WATTS BAR NUCLEAR PLANT (WBN) UNITS 1 AND 2 - REQUEST FOR ADDITIONAL
INFORMATION ON FSAR CHAPTER 3 AS REVISED BY AMENDMENT 79 (TAC NOS. M88488
AND M88489)

This letter provides TVA's response to the NRC's request for additional
information (RAI) dated October 11, 1994, concerning the subject FSAR
chapter for WBN.

WATTS BAR NUCLEAR PLANT UNITS 1 AND 2 FINAL SAFETY ANALYSIS REPORT (FSAR), CHAPTER 3 REQUEST FOR ADDITIONAL INFORMATION (RAI) RESPONSE

FIG. 1. GEOMETRY OF NASS MODEL (CASE NO. 1) & ICS INTERFACE NODES

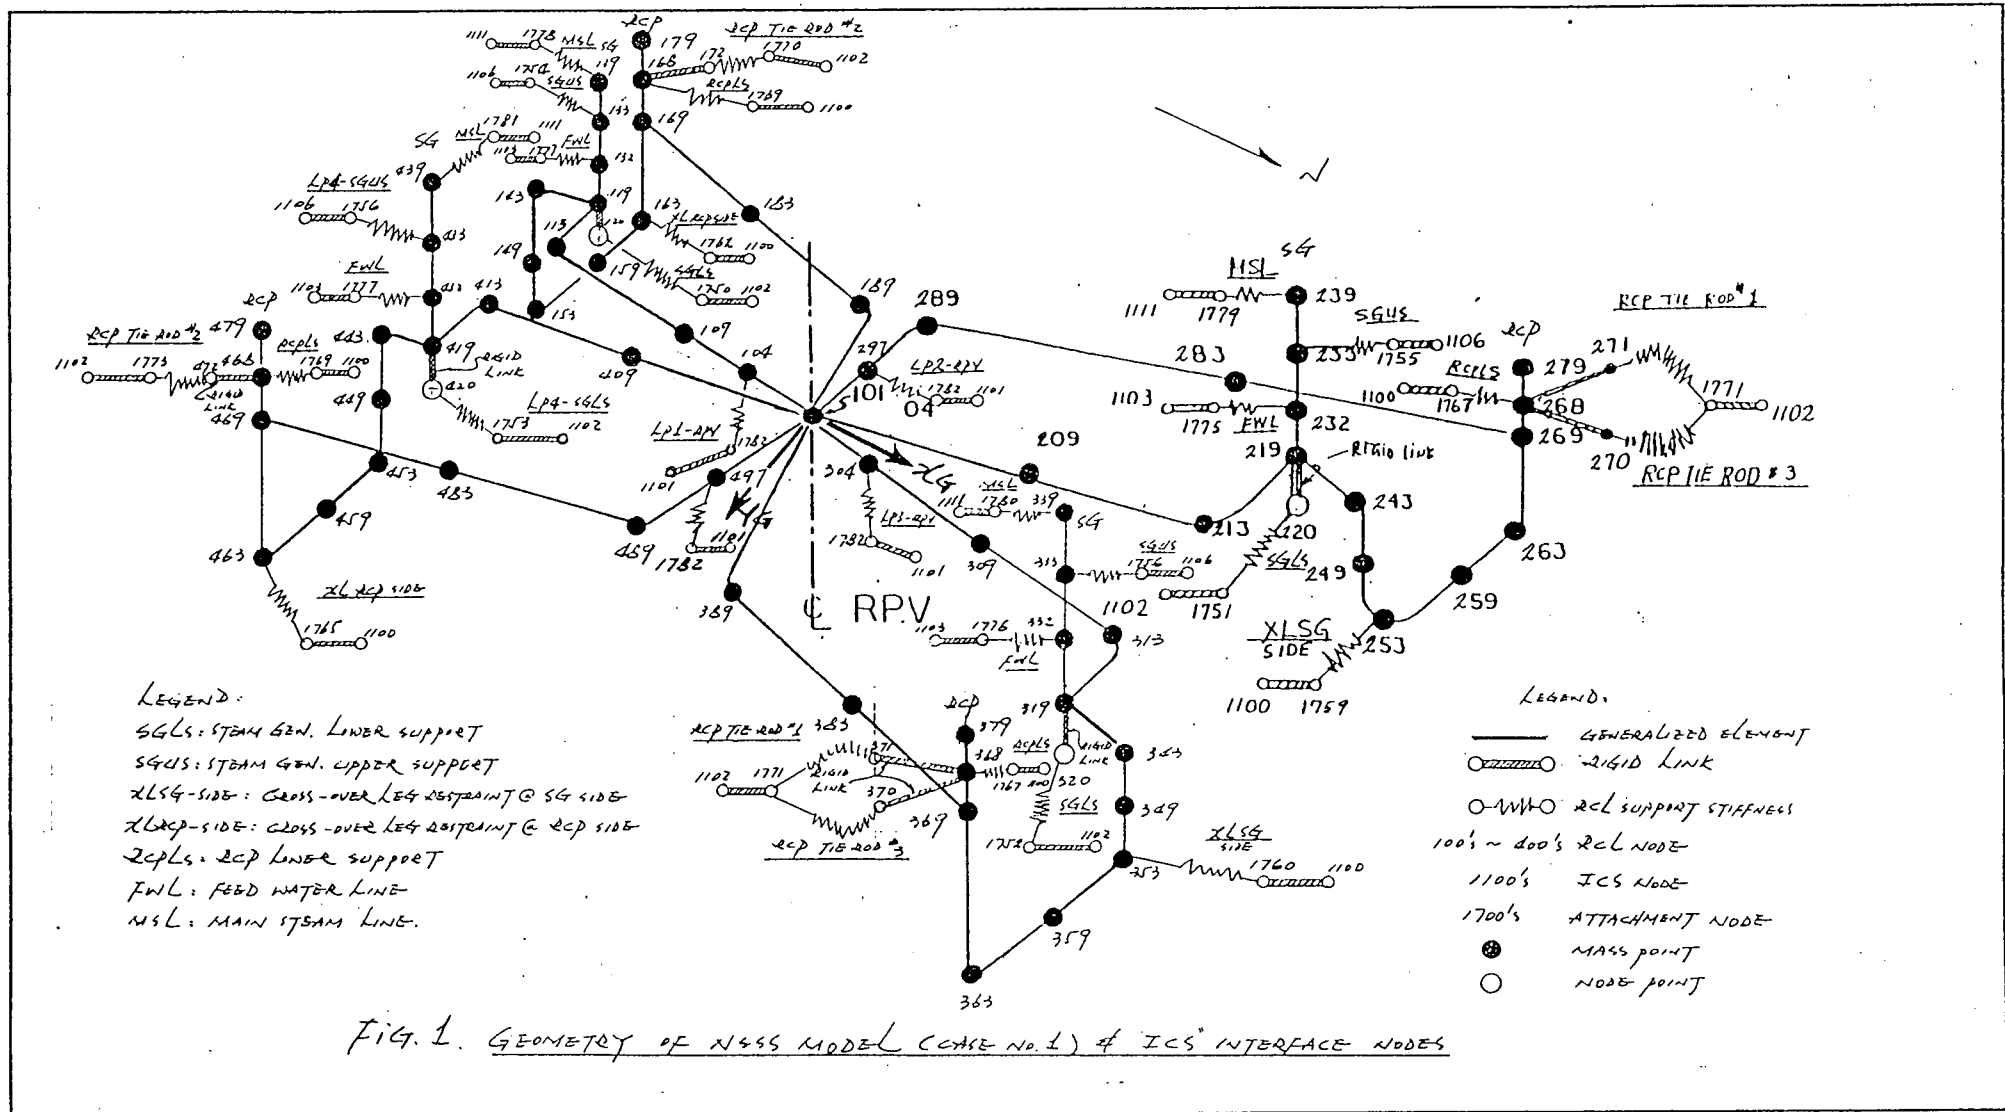
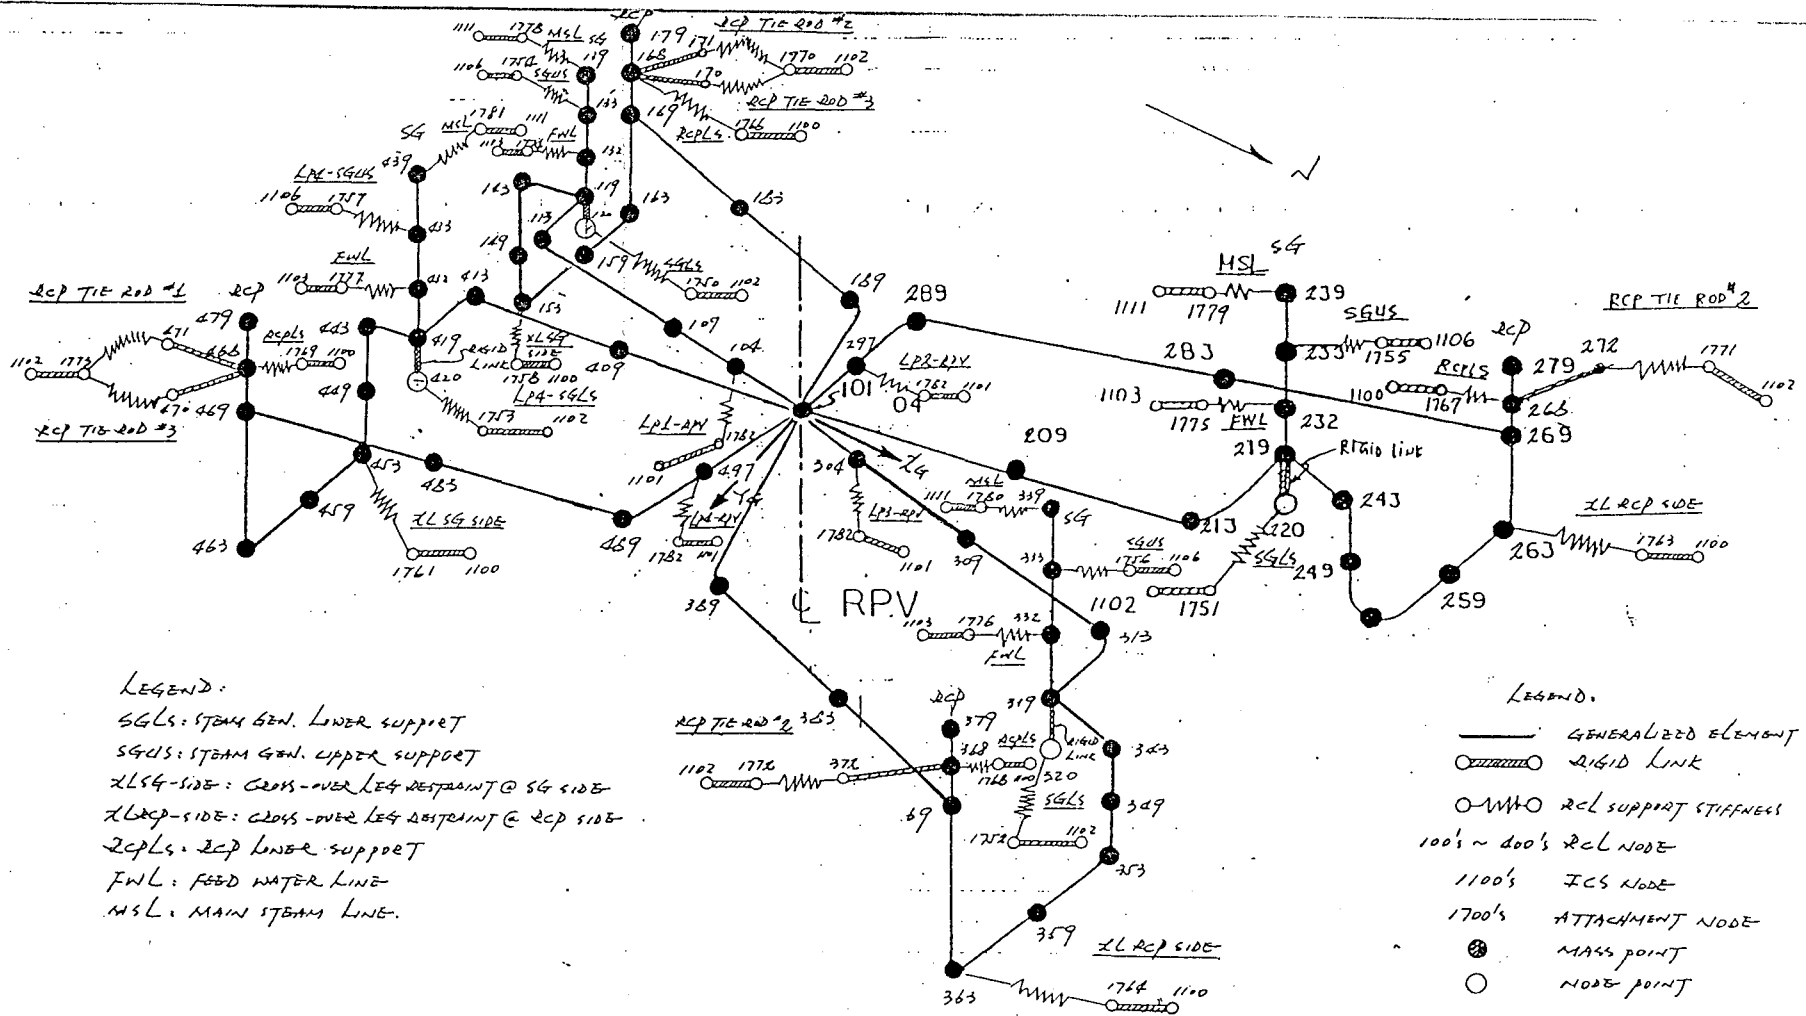
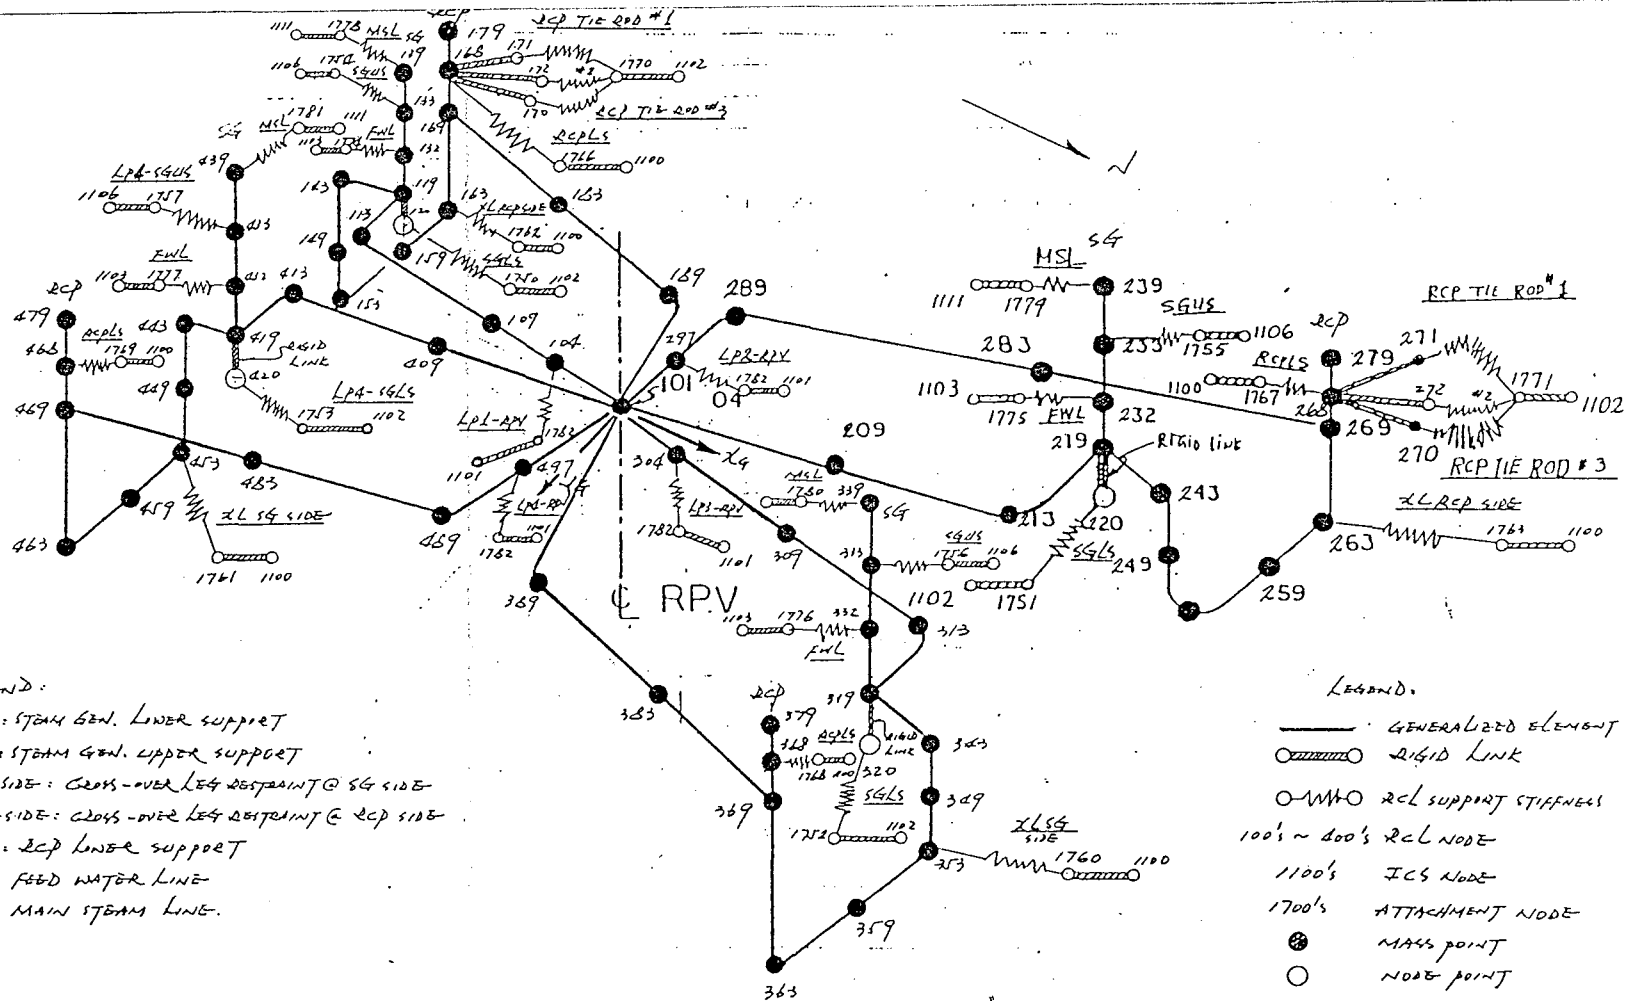
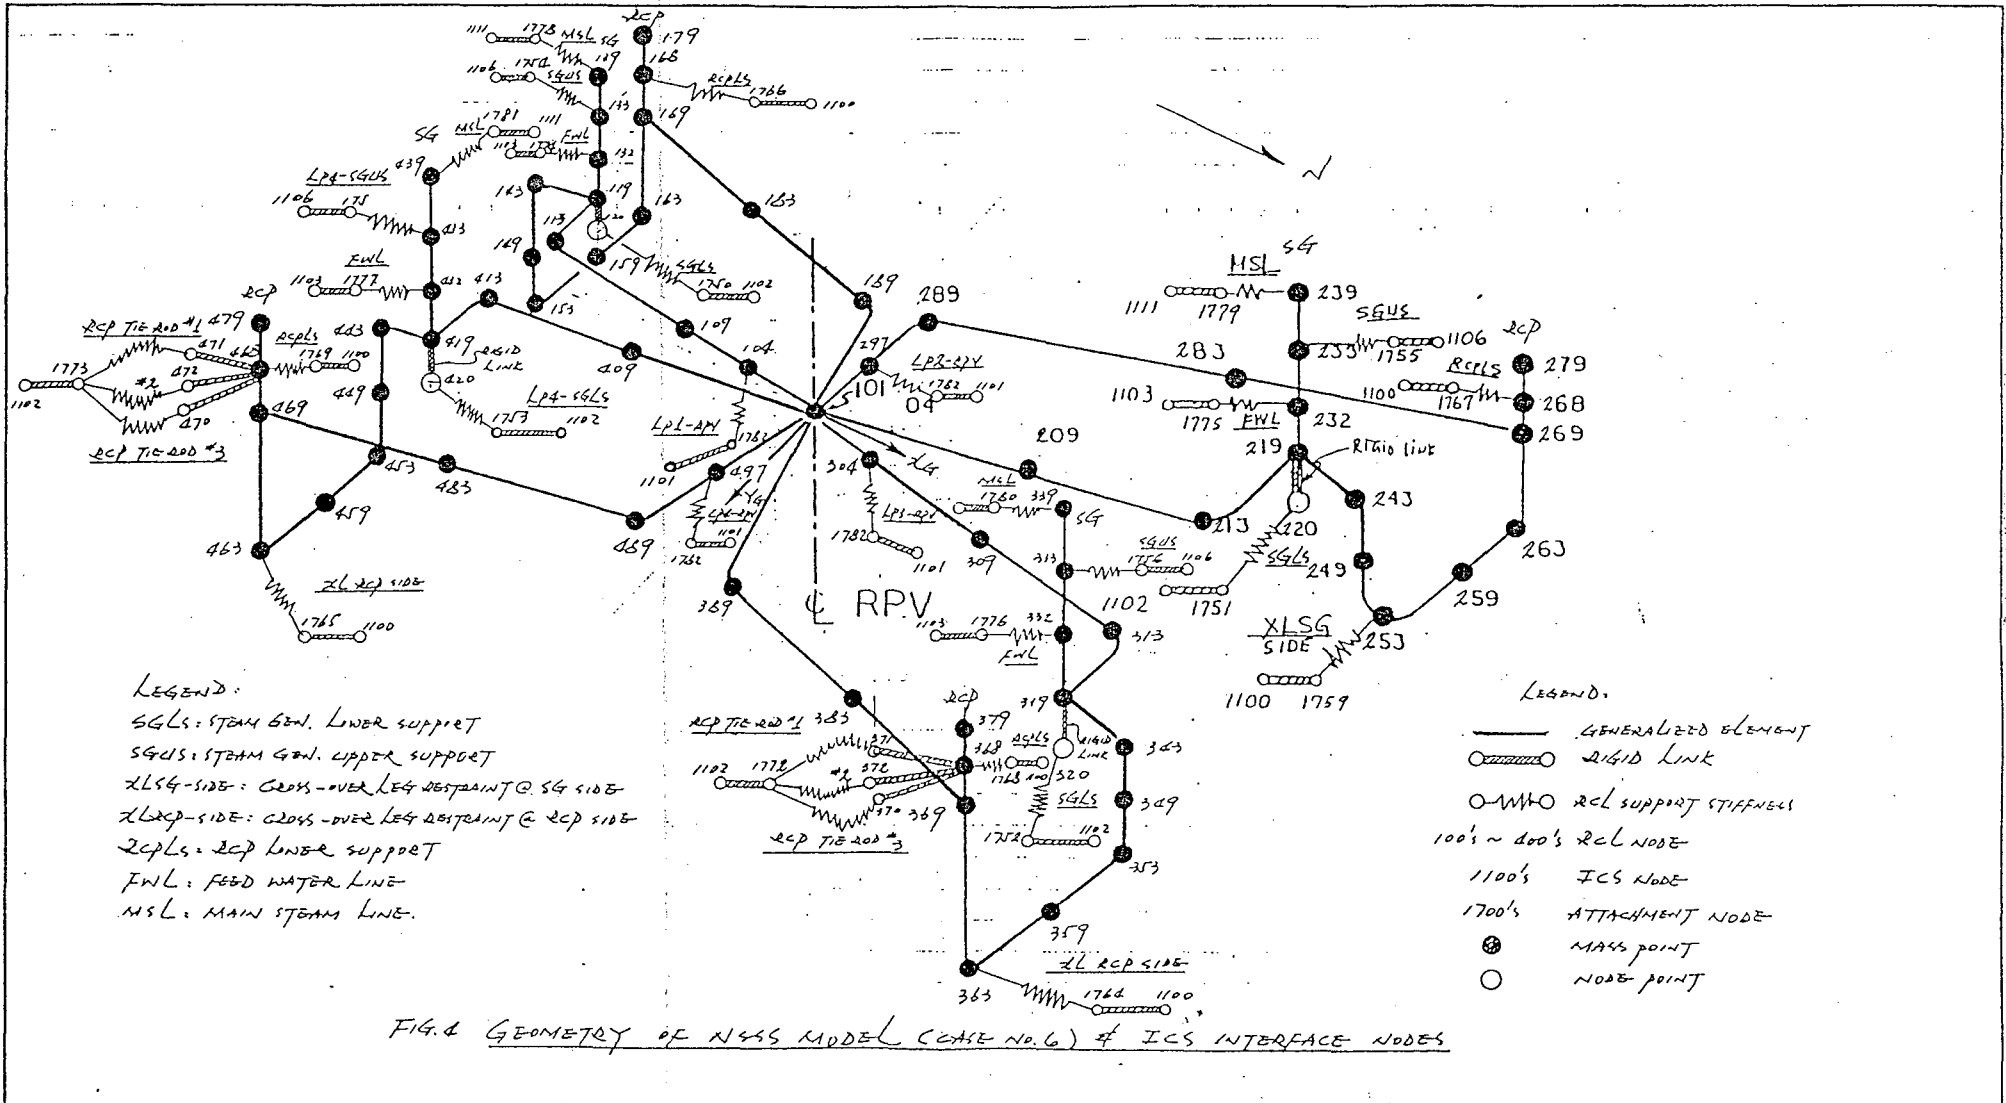
"The staff concludes that the applicant's response is not sufficient. To be acceptable, the applicant should include more detailed discussion of the combined ICS and NSSS models as an appendix to the WBN FSAR. As a minimum, the additional information should include:

1. Geometry and sketches of the model,
2. Engineering data, such as, mass, spring, damping, size and location of the gaps, location of one-way hangers,
3. Description of modelling of gap and one-way hanger and validation of such model,
4. Detailed description of four linearized NSSS support stiffness and a discussion of how such supports adequately represent the nonlinear system being evaluated,
5. Discussion of governing equation of motion and the validation of numerical integration algorithm including stability and error estimate as discussed in "Analysis of Numerical Methods," E. Isaacson and H. B. Keller, 1966 .
6. Validation of overall model and
7. Summary of the calculated stresses of the critical members both in concrete structure and piping and supports, corresponding allowable stresses and references from which the allowable stresses are quoted."

Figures 1 thru 4 in Attachment 2 of this enclosure, show the analytical models used to represent the NSSS components in the coupled model. Due to the presence of gaps and tension-only tie rods at the NSSS supports, these supports exhibit nonlinear behavior under dynamic loading conditions. However, the use of a complex nonlinear model is impractical for the production of responses and ARS for design usage. Therefore, a conservative linear model was used to develop ARS for the coupled model.

For the purpose of linear response analyses, four linearized NSSS analysis cases, each with a unique set of linearized NSSS support stiffness, are used to bound the nonlinear support behavior under various dynamic loading conditions. These four cases are designated as NSSS Analysis Cases 1, 3, 5, and 6 (Reference 1). Specifically, for each NSSS analysis
